RE: A6MARR - Public Inquiry

From: Naz Huda
Sent: 08 October 2014 07:51
To: John Seed (jrs@brownrural.com)
Cc: Stephen Sauvain QC (SSauvain@kingschambers.com); Alan Evans (AEvans@kingschambers.com); Church, Henry @ London HH <Henry.Church@cbre.com> (Henry.Church@cbre.com); John Hill
Subject: A6MARR - Public Inquiry

SEMMS - A6 TO MANCHESTER AIRPORT RELIEF ROAD

Access Plan
PROPOSED ACCESS PLAN
OPTION 1

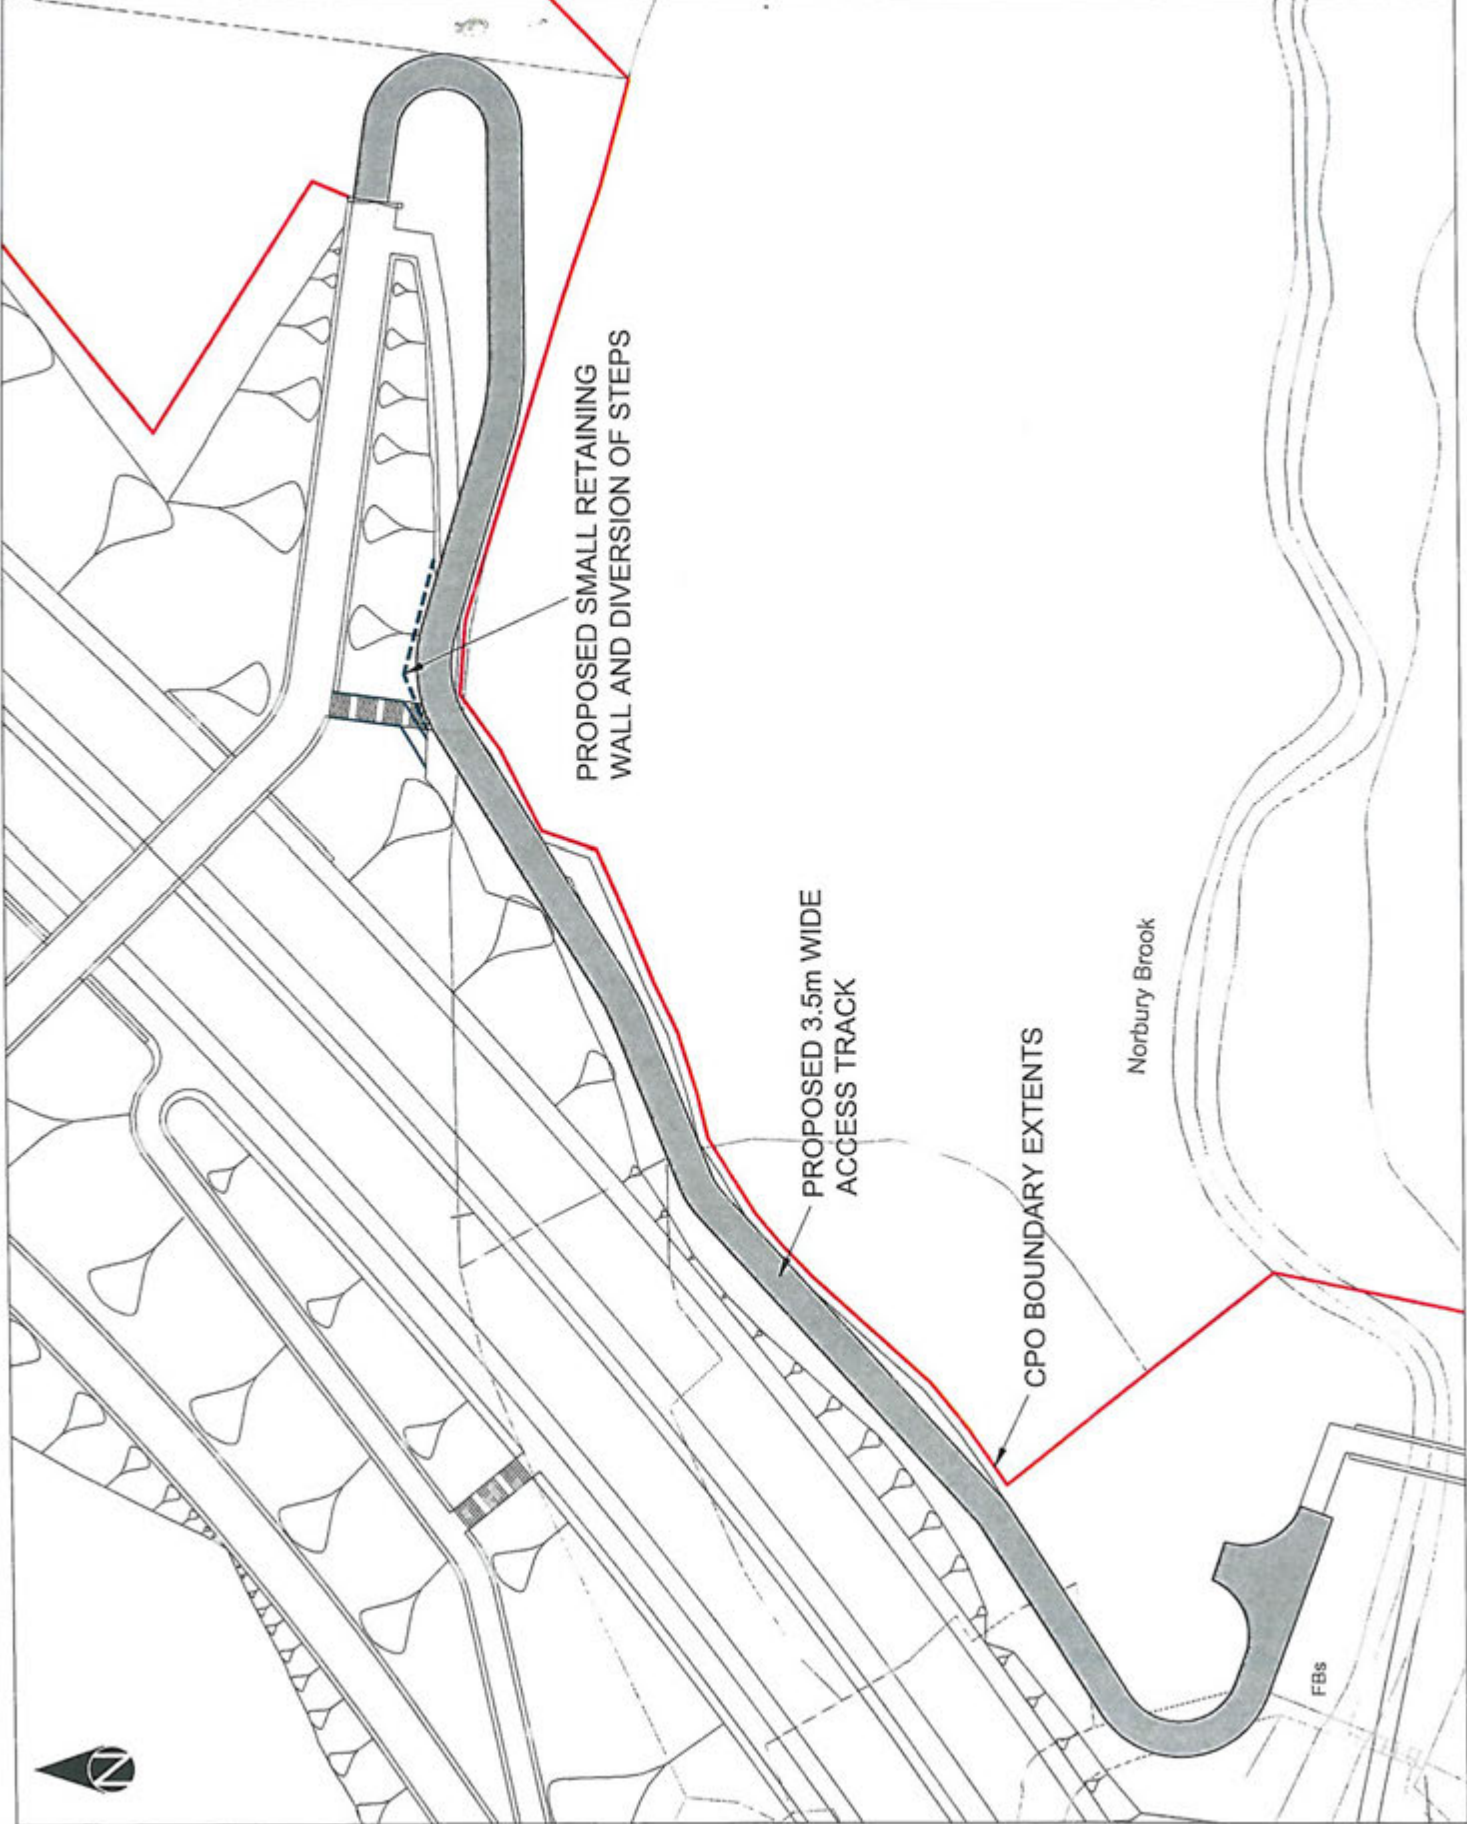
Please find attached drawing **1007/3D/DF7/A6-MA/GA/395** – this is a proposed PMA for the benefit of Helen Harrison, your client's tenant of the woodland area south of Old Mill Lane. We currently believe that there is no relevant PMA stopped up as part of the works, notwithstanding the site visit with the Inspector. In any case the proposal is for the diverted PRoW to be widened to accommodate a widened 4m track. The pinch points are the turning manoeuvre off the southern ramp off the bridge and the turning head proposed between the existing footbridge and the proposed new footbridge the west. We have carried out further swept path analysis to ensure that a tractor and trailer can carry out the manoeuvres, some widening around these pinch points may be required but I am confident we can do this within the current CPO extents.

The proposal requires no additional land outside of the existing CPO extents, stay within the planning consent boundary and requires no further woodland to be cleared than already set out. It does requires a modification to the SRO though.

If your client is amenable to this solution or suggests something else please can you advise asap in order for a proposed modification to be composed by us and submitted to the Inspector.

86 ALBANY RD - AERIAL PHOTO PROPOSED CYCLIST PROVISIONS AND TRACKING

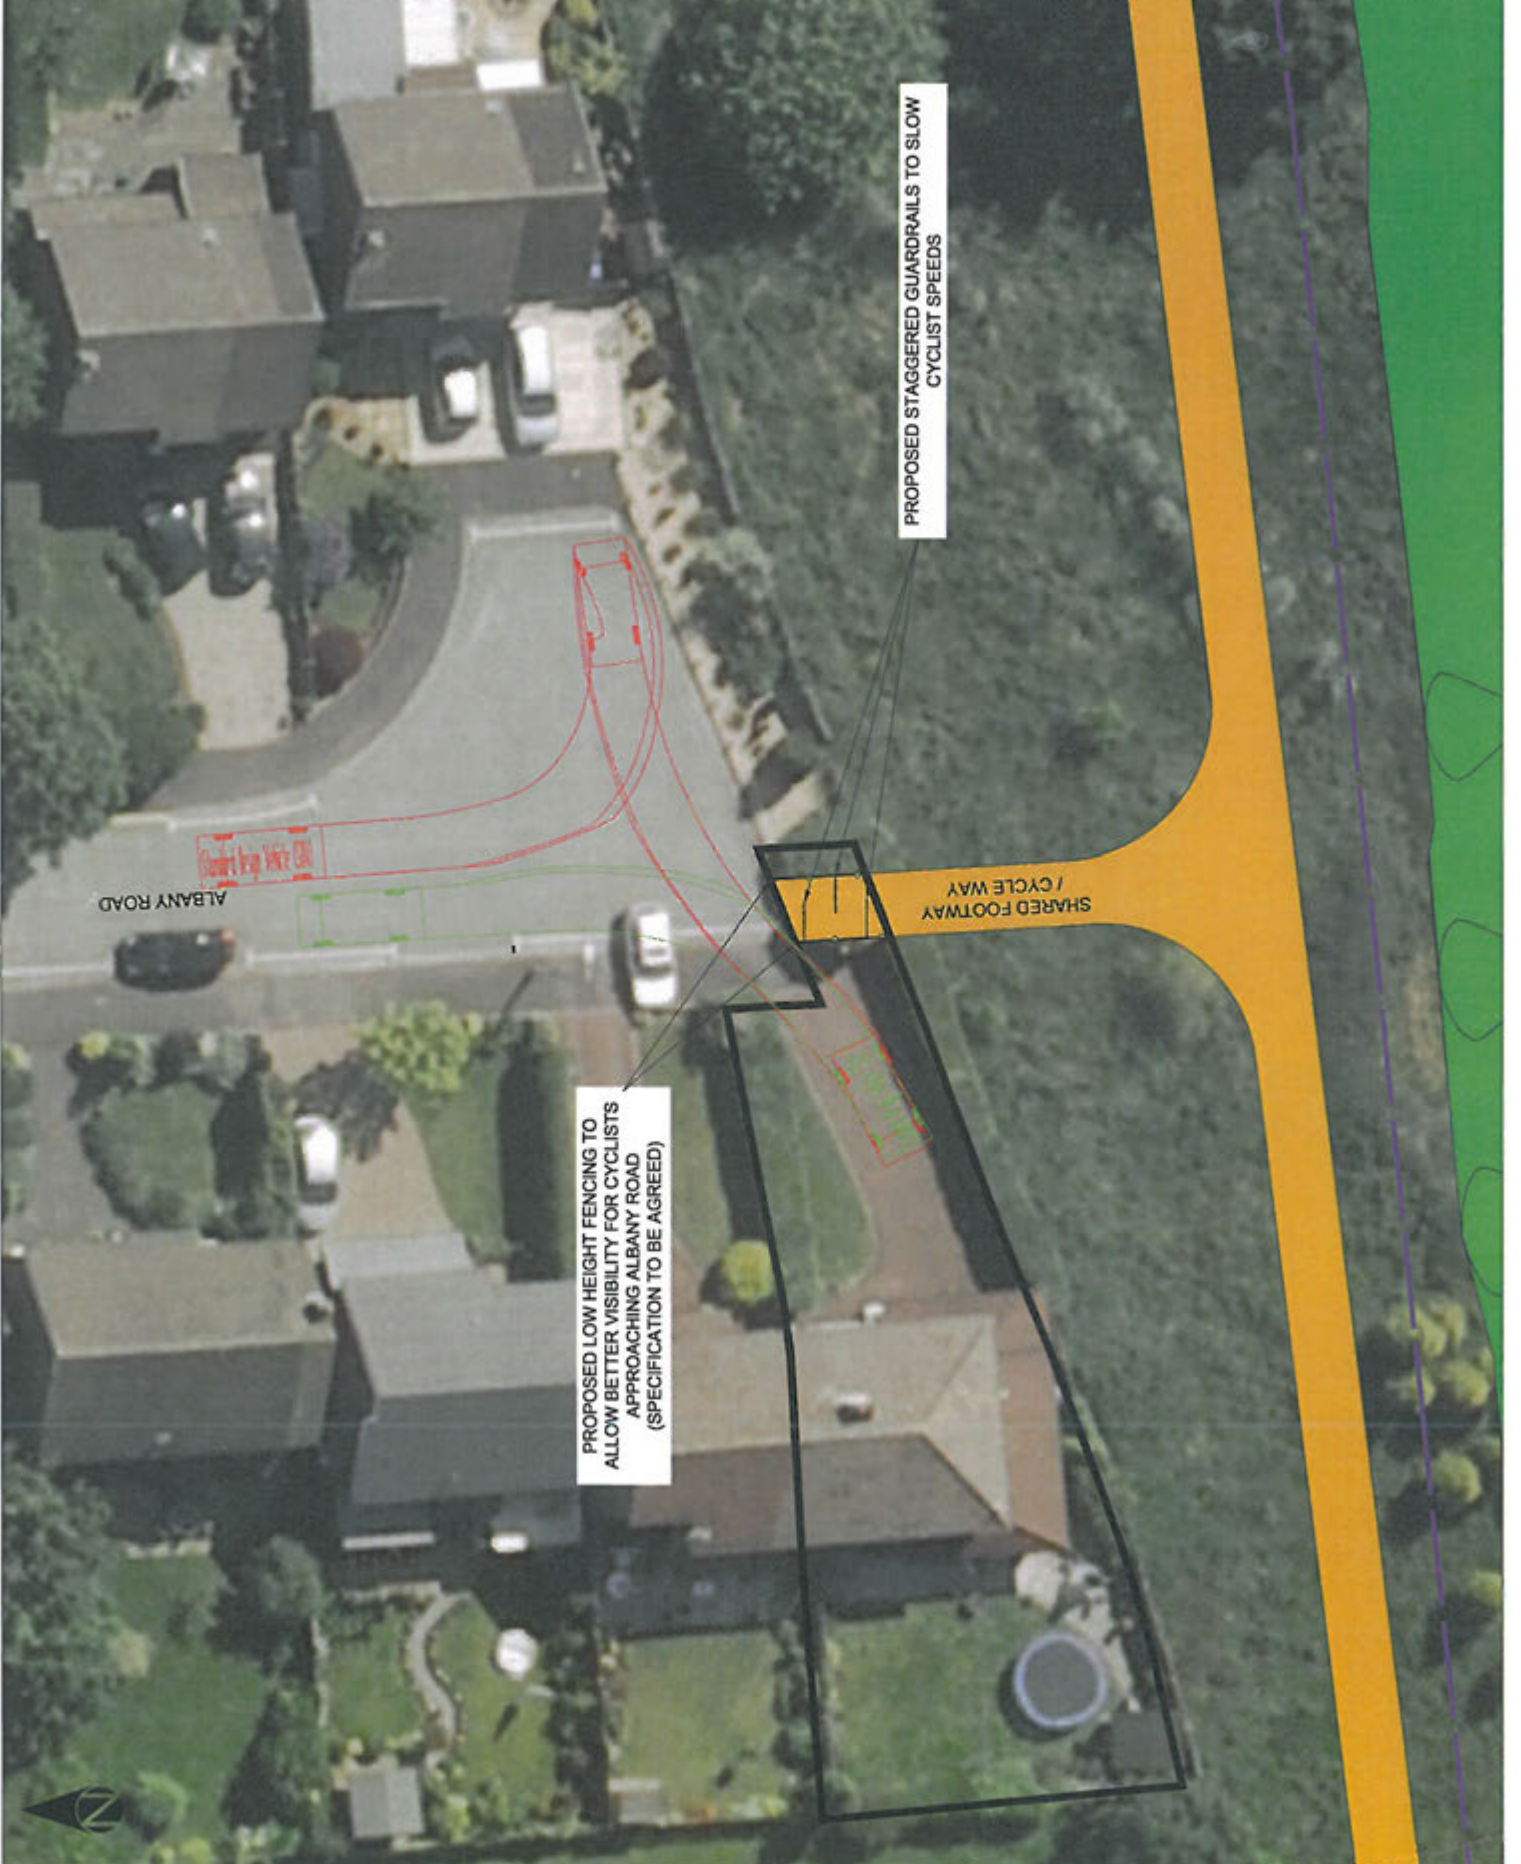
Please find attached drawing **1007/3D/DF7/A6-MA/GA/361 AERIAL REV B** – The 'swept path analysis' indicates that the movement in and out of the driveway for a Standard Design Vehicle i.e. a car, is unimpeded by the proposed works. We have updated the drawing from our rebuttal to take cognisance of the lawn extents and position. The aim of the design of the cycleway / footway was to ensure that the driveway was left unaffected and I believe the design achieves this and always has done. We will issue this to the Inspector via the Programme Officer today. If you have any further queries please let me know although we obviously re-convene at the Inquiry later this morning.

PROPOSED LOW HEIGHT FENCING TO ALLOW BETTER VISIBILITY FOR CYCLISTS APPROACHING ALBANY ROAD (SPECIFICATION TO BE AGREED)

PROPOSED STAGGERED GUARDRAILS TO SLOW CYCLIST SPEEDS
